**Approved baseline and monitoring methodology /
methodological tool clarification response form
(Version 03.0)**

Date and number of Panel / WG meeting:	20 – 24 Sept 2021 / MP 86
Title/Subject of the request for clarification:	Clarification on how to calculate the EGPJ as the quantity of electricity generated by the project activity and supplied to the grid and to the electricity consuming facility, under ACM0002
Reference number of the request for clarification:	AM_CLA_0290
Exact reference (number, title and version) of the methodology or methodological tool to which the request for clarification applies:	ACM0002: Consolidated baseline methodology for grid-connected electricity generation from renewable sources --- ver. 12.3.0
Fast track or Regular track:	<input type="checkbox"/> Fast track <input checked="" type="checkbox"/> Regular track

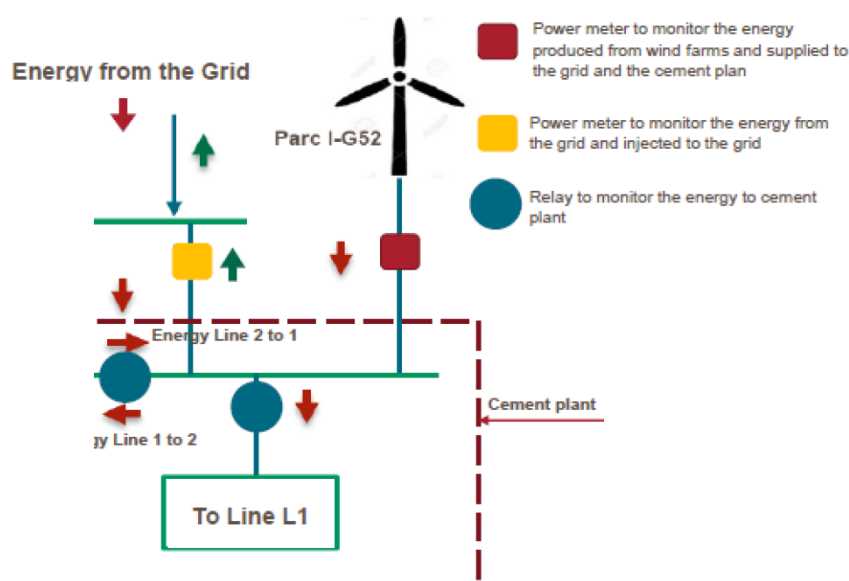
You are kindly requested to share a line diagram that shows the points where electricity supplied by the project activity to the grid and the cement plant are monitored. Separate line diagrams to indicate the project boundary in the baseline and project situation including metering points may be provided.

1. A line diagram that shows the points where electricity supplied by the project activity to the grid and the cement plant are monitored.

The Lafarge complex includes the wind Park I (CDM project 0042), the wind Park II & III (CDM project 5991) and the cement plant. The energy supplied by the Complex to the grid (EGexp) and the energy received from the grid (EGimp) are monitored by the bidirectional meters M4 and M5.

As consequence of the energy supplied to the grid can be injected by the line 1 and/or 2, it is not possible to know the electricity supplied by each wind park to the grid, and it is monitored the energy supplied to the grid by all wind parks.

Likewise, the energy supplied by the project activity to the plant is not monitored separately either and is only calculated considering the energy generated by all wind parks and the energy supplied to the grid.

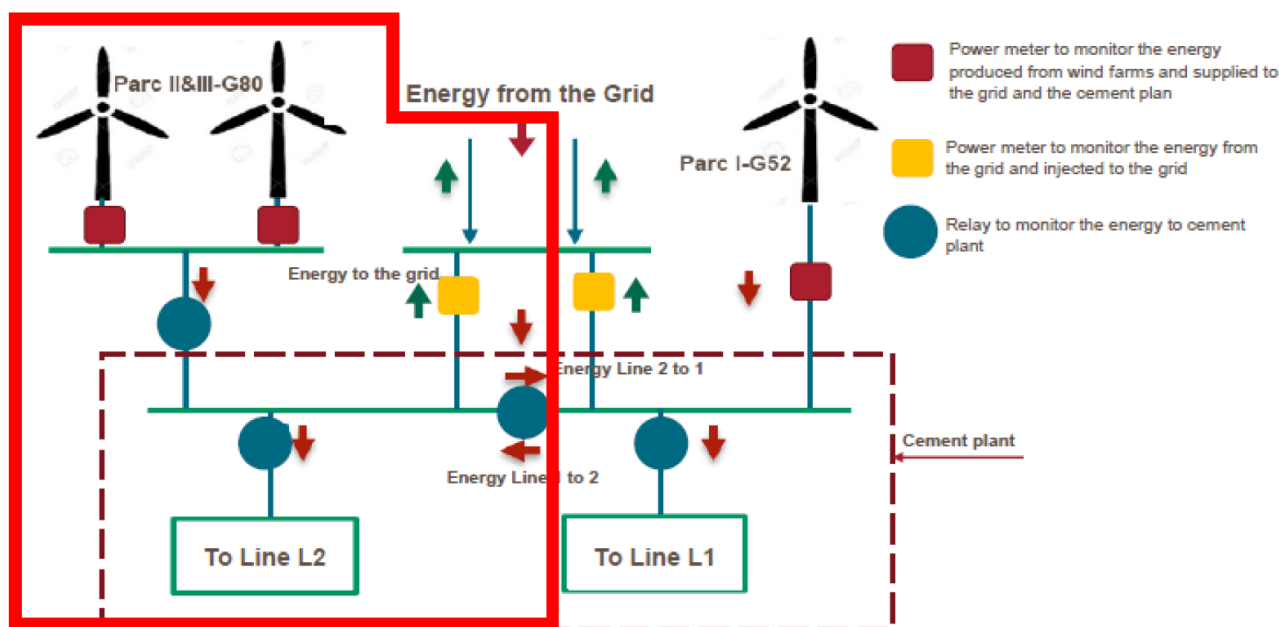
2. A line diagram to indicate the project boundary in the baseline situation including metering points

The project boundary in the baseline situation should be that the energy consumed by the cement plant would be supplied by the wind Park I or/and the national grid. Please, see figure B3 of the registered PDD of the project activity 0042.

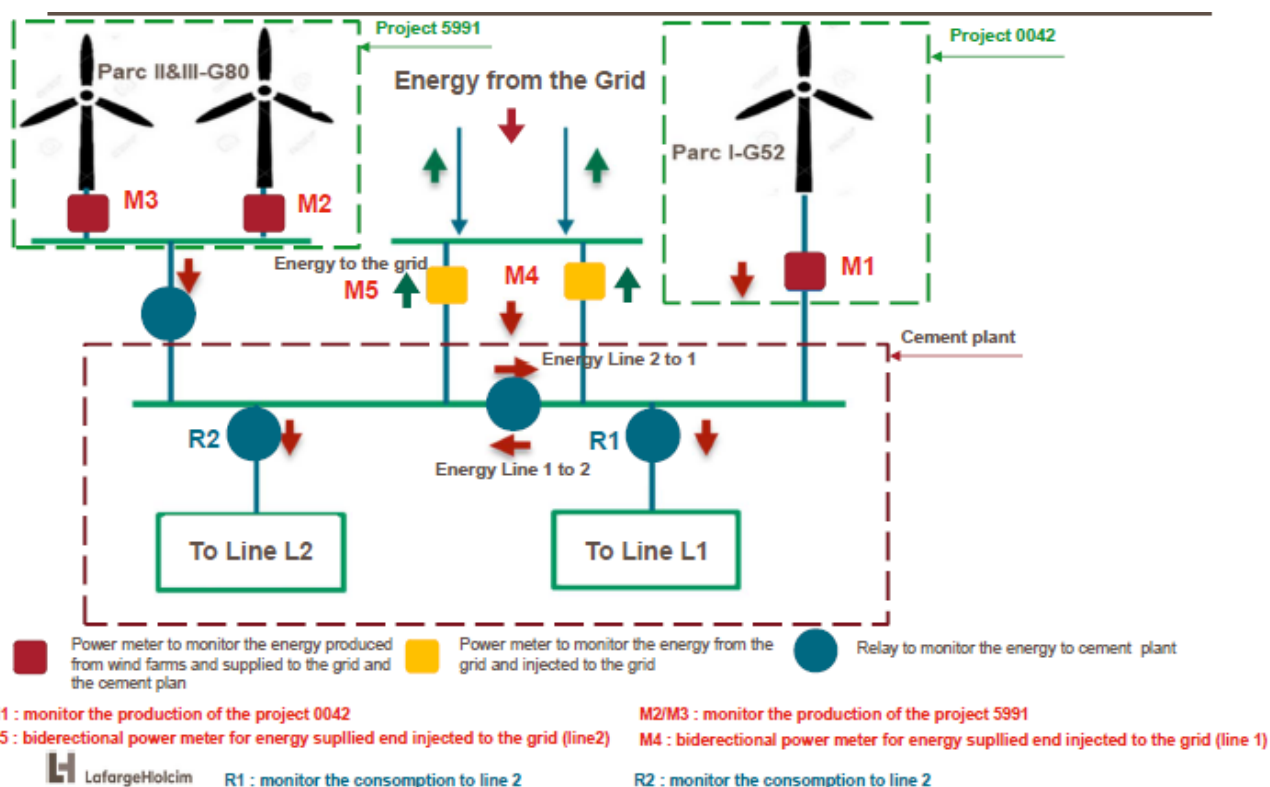
3. A line diagram to indicate the project boundary in the project situation including metering points, identifying clearly the new additional transmission lines and metering points included due to the project activity.

The project boundary in the project situation including the new additional transmission lines and metering points included due to the project activity are identified clearly into the red figure. Please, see figure included in Annex 4 of the registered PDD of the project activity 5991.

- Referring to the line diagram you have shared, could you please clarify the metering locations for project 0042 and project 5991; and
- How the net electricity supplied to the grid by each project is monitored and calculated noting that "the

energy supplied to the grid can be injected by the line 1 and/or 2, it is not possible to know the electricity supplied by each wind park to the grid, and it is monitored the energy supplied to the grid by all wind parks". Also clarify how the procedure used to monitor net electricity supplied to the grid is in-line with the respective applied methodologies.

As we explained in previous documents, the net electricity supplied to the grid and the cement plant by each project cannot be monitored, but the net energy generated by each project is monitored (meters M1 and M2/M3), and this energy is the quantity of energy displaced by each project from the grid, well supplied directly to the grid or to the cement plant that replaces the consumption from the grid if the project was not implemented.

In this case, the net electricity supplied to the grid by the project (directly or indirectly supplying it to the cement plant) would be equivalent to the net energy generated by the project 5991 and monitored by the meters M2 and M3, minus the transmission and transformation losses (2%). This case would be requested in a post registration change once the clarification would be answered accepting the consideration of the parameter EGPJ_Add,y equivalent to the electricity generated.

The project participant may wish to explore the possibility to claim emission reductions against the portion of electricity supplied to the grid by the project 5991, submitting a post-registration change request as per section 8 of the "CDM project standard for project activities", version 2.0 providing details regarding the method used to determine the portion of the electricity supplied to the grid, as the line diagram submitted by the stakeholder appears to indicate that the meters M4 and M5 measures the electricity supplied to the grid by both project 5991 and project 0042.
